PERMIT MODIFICATION APPROVAL

Re: Permit Modification Approval for API Number 6101667 , Well #: H1
DRILL HORIZONTAL PRODUCTION SECTION IN FIFTH SAND

MODIFICATION REQUEST

STEP #1 MODIFIACTION FOR YOST H-1 5TH SAND FORMATION
ALL CASING WAS CEMENTED BACK TO SURFACE

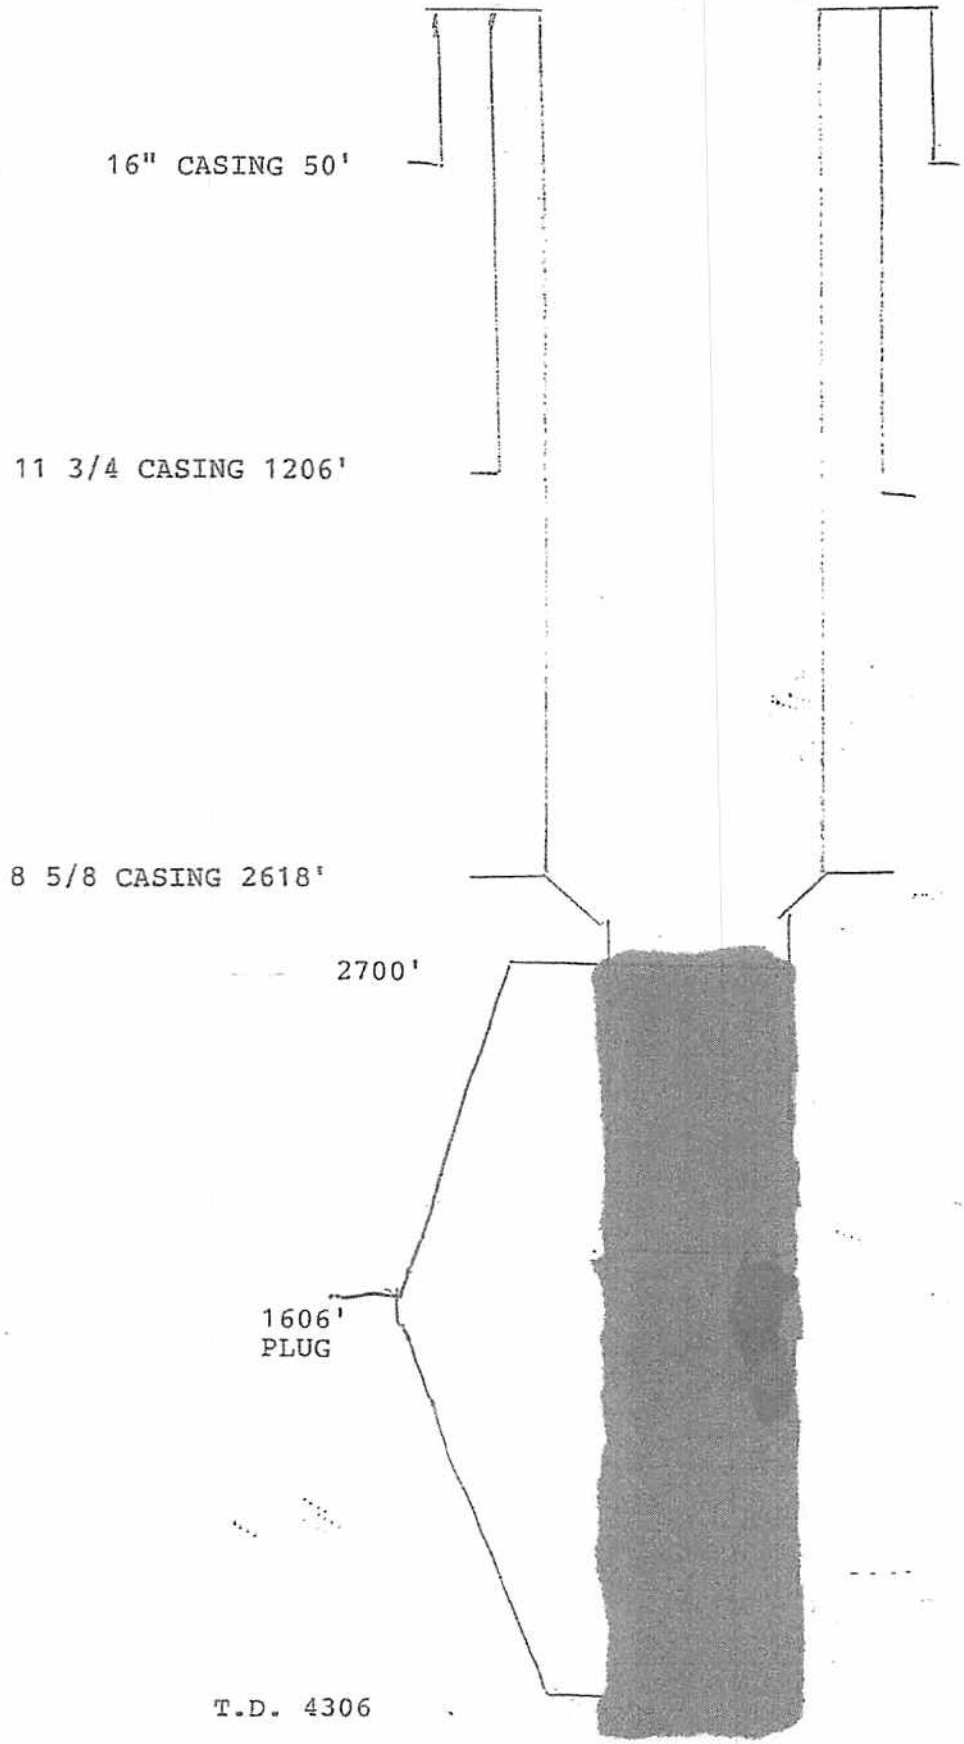
Step #1

1. Cement Test Hole from 4,306' back to 2,700'

Plan: Design #1 (Well #1/Wellbore #1)

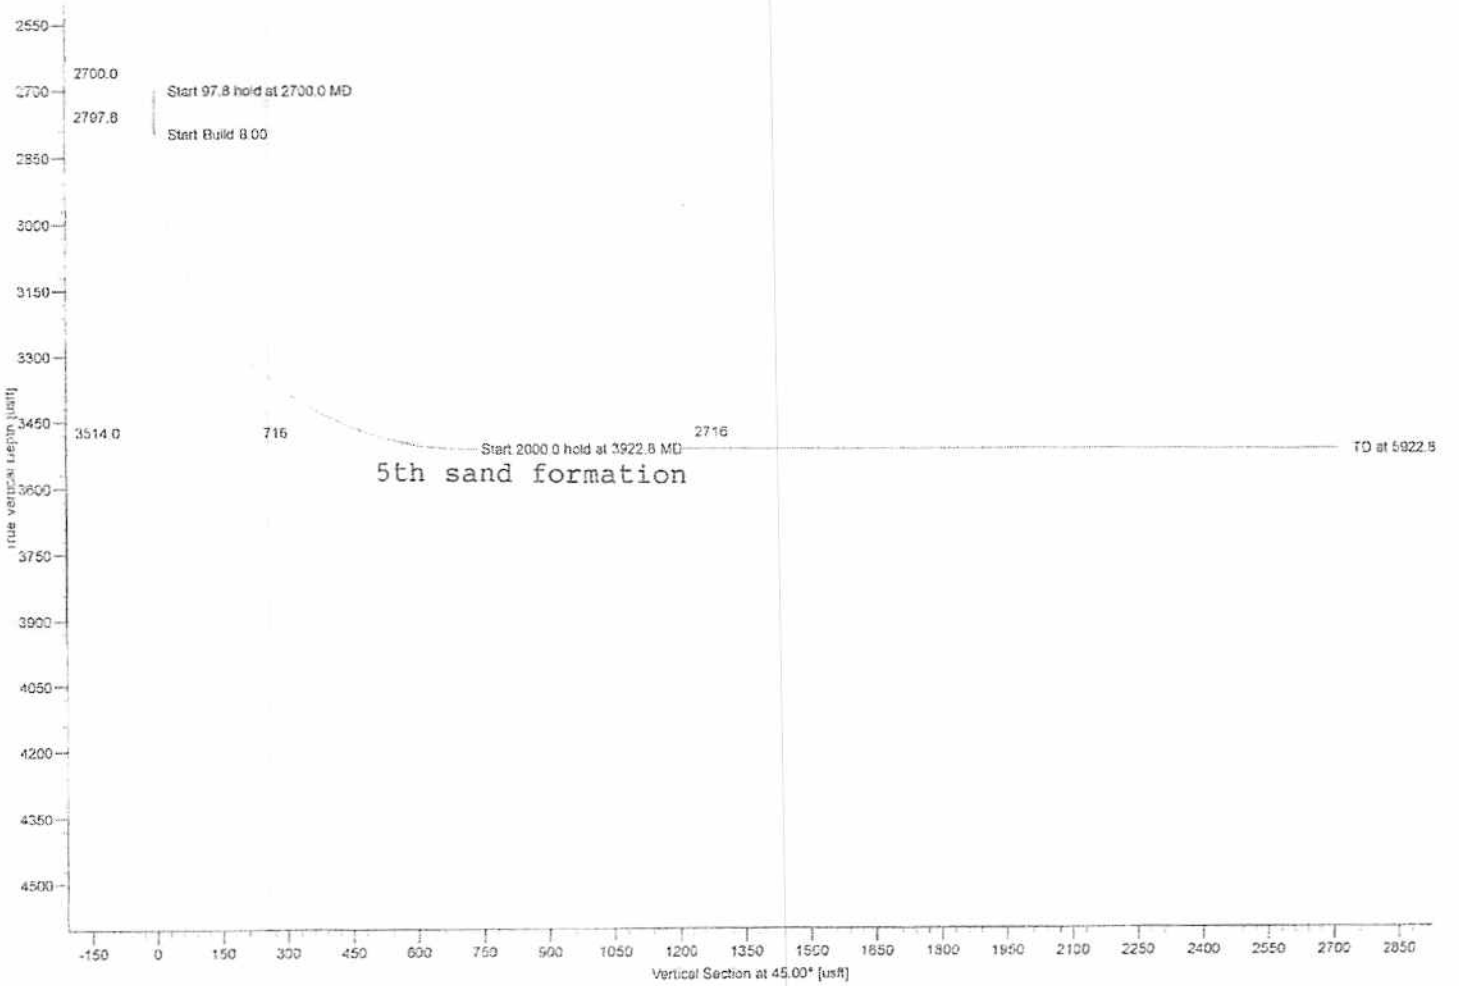
Step #2 Drill out Horizontal

1. Start kick-off point - 2797.8' Elv.
2. Start horizontal point - 3,514' Elv.
3. Total footage of horizontal length - 2,050'
